City of Stamford
Zoning Board

STAFF REPORT

TO: CITY OF STAMFORD ZONING BOARD
FROM: VINEETA MATHUR, PRINCIPAL PLANNER
SUBJECT: ZB #225-20 & 21, 60 Palmers Hill Road, Text Amendment, General Development Plan & Special Permit
APPLICANTS: Richard W. Redniss (22 1st Corp.) - Text Amendment
 Children’s Learning Centers of Fairfield County Inc. (GDP, Special Permit)
DATE: July 14, 2025
MASTER PLAN: Master Plan Category 3 (Residential – Low Density Multifamily)
ZONING: C-D (Commercial Design)

GENERAL DEVELOPMENT PLAN

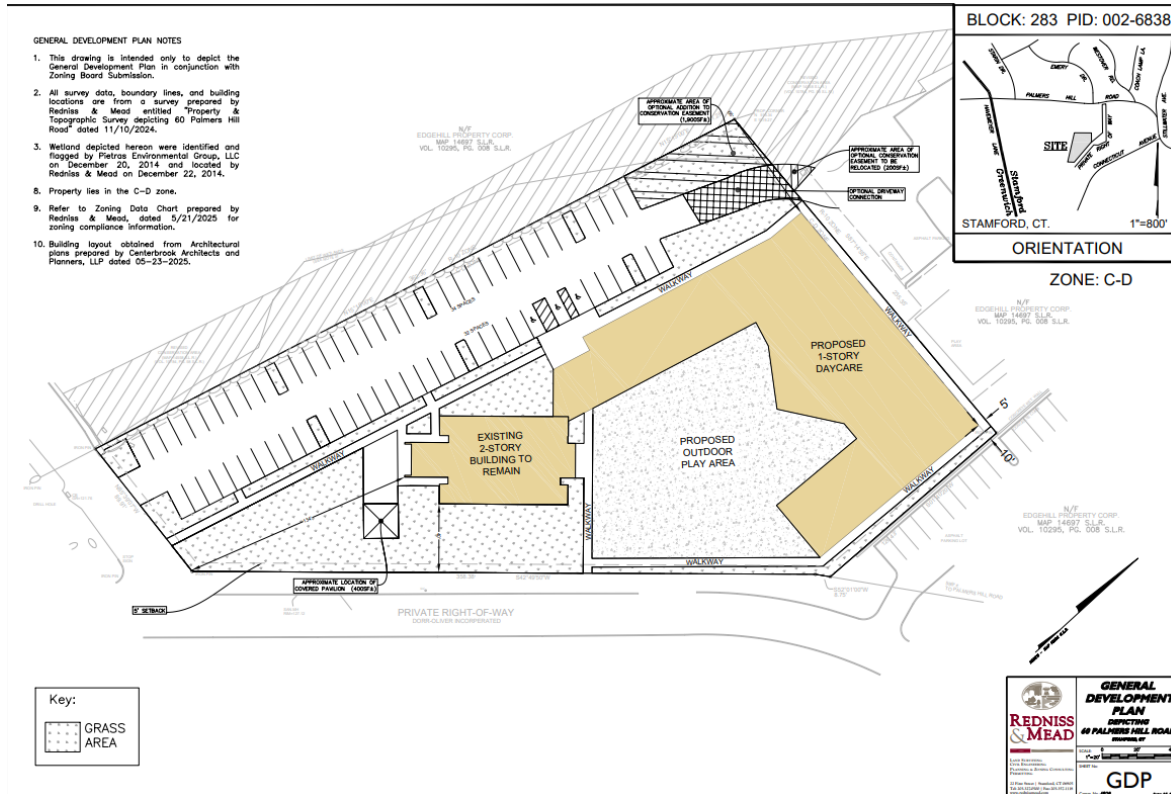
*The proposed parking is consistent with the parking standards of Section 12. The General Development plan shows 66 parking spaces whereas the Zoning data chart notes 68 parking spaces. The number should be clarified. The proposal will exceed the minimum requirement. **Complies.***

Robert Clausi, Executive Director, Environmental Protection Board provided comments in a memo dated October 30, 2024 and noted that EPB has no objections to the text amendment. With regards to the Special Permit and GDP, Mr. Clausi noted that a wetland permit will be required prior to a final site plan approval. Further, he expressed concerns with the 'Optional Driveway Connection' shown on the GDP because of its proximity to the wetland.
